~~Re: Clear Zone Variance Request~~ Form
Node Name-City Address

~~Code Section:
Standard Required:
Variance from Standard Requested:

For example:
Code Section: AASHTO Clear Zone Requirement (per RDCS, Section 1.01
Scope)
Standard Required: X' clear zone required
Variance from Standard Requested: X' clear zone provided~~

Attachment 1

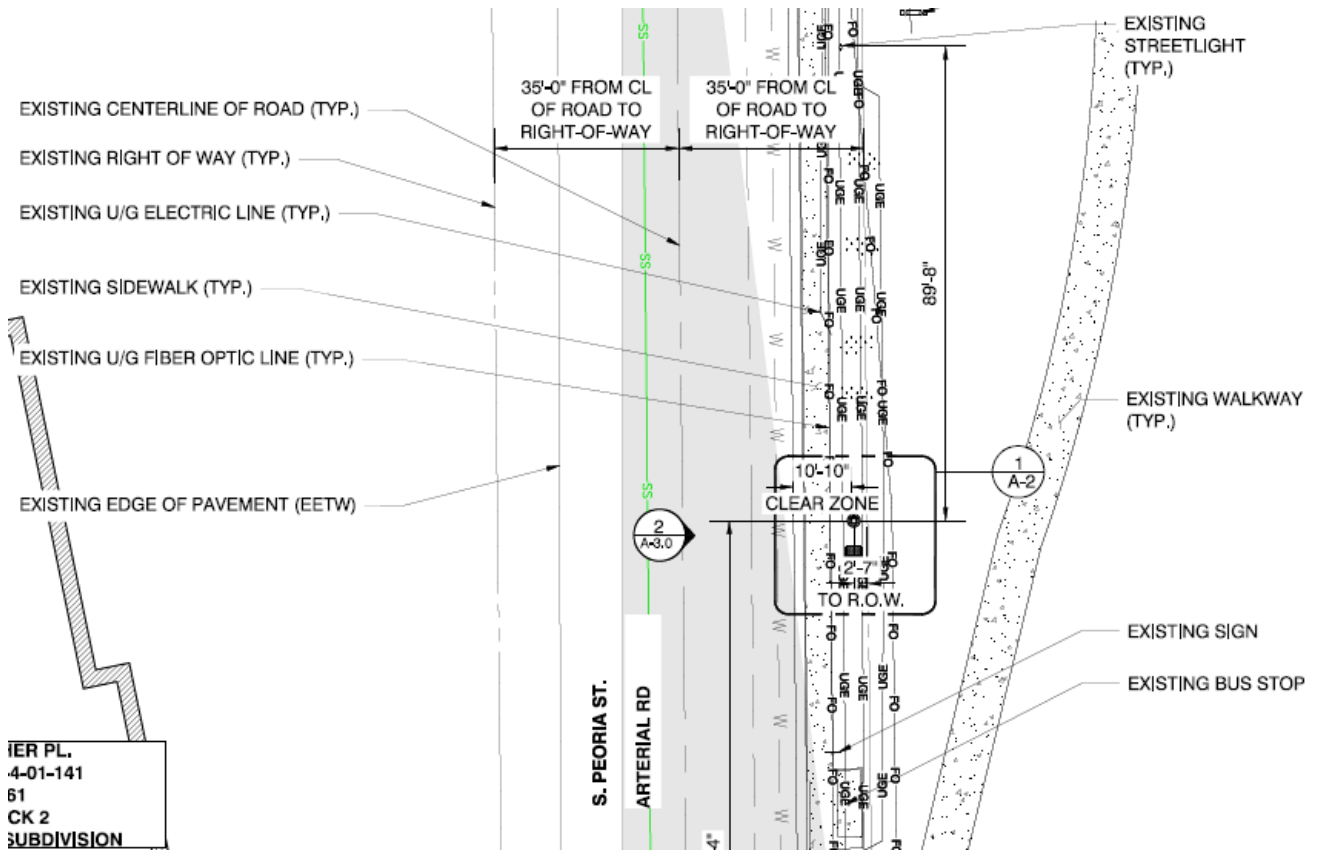
1. Company Name is unable to meet the 20-ft clearance zone requirement due to limited right-of-way

~~City Comment Issued 3/30/2021 by Carlie Campuzano:~~

~~“Same comment as previous: Pole appears to be within clear zone, move pole or protect object”.~~

Here, the City’s 20-ft clearance zone requirement is unattainable due to limited right-of-way. As reflected in the plans and drawings submitted to the City and once again proffered herein, Company Name facility will be installed at 10-feet and 10 inches from the curbside. Although there is another 2-ft and 7 inches remaining within the right-of-way, Company Name is unable to push back any further due to underground electric utilities. Even if Company Name was able to push back to utilize all right-of-way space in its entirety, the 20-ft clearance zone requirement would still not be possible as a lateral offset of 13-ft and 5 inches is the maximum setback possible before Company Name would be pushed out of the right-of-way. Please refer to Attachment 1 below.

Attachment 2

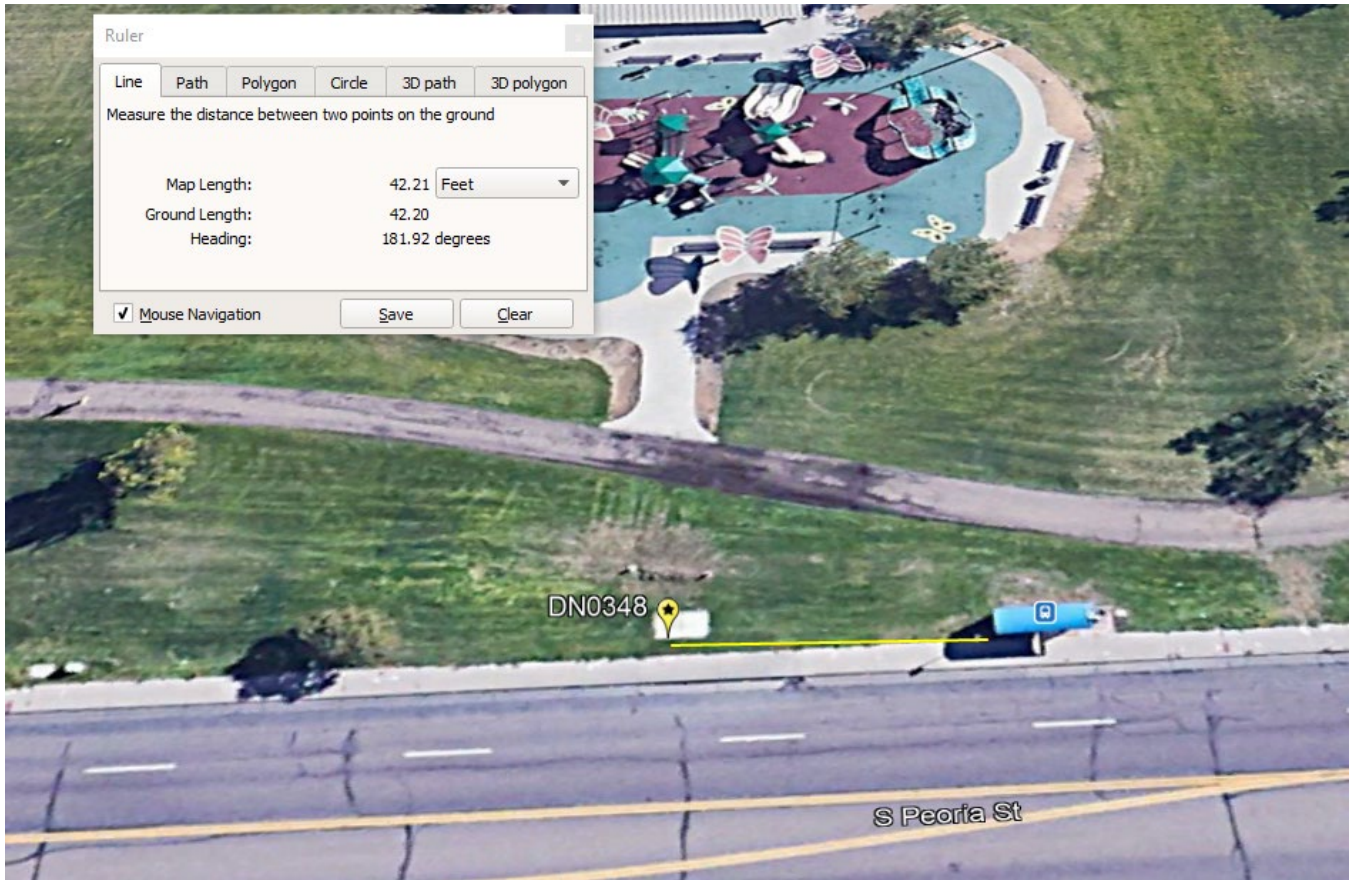
- 2. The proposed node location is not a candidate for guardrail protection due to the nearby bus stop interference therefore, the required length of need would not be attainable**

~~City Comment Issued 3/30/2021 by Carlie Campuzano:~~

~~“Same comment as previous: Pole appears to be within clear zone, move pole or protect object”.~~

As depicted in Attachment 2 below, Company Name proposed node location is approximately 42-feet to the north of an existing bus stop. Since guardrail protection would interfere with the bus stop’s intended use and pedestrian accessibility, the required length of need is not attainable at this location; therefore, Company Name is unable to deploy guardrail protection at this location.
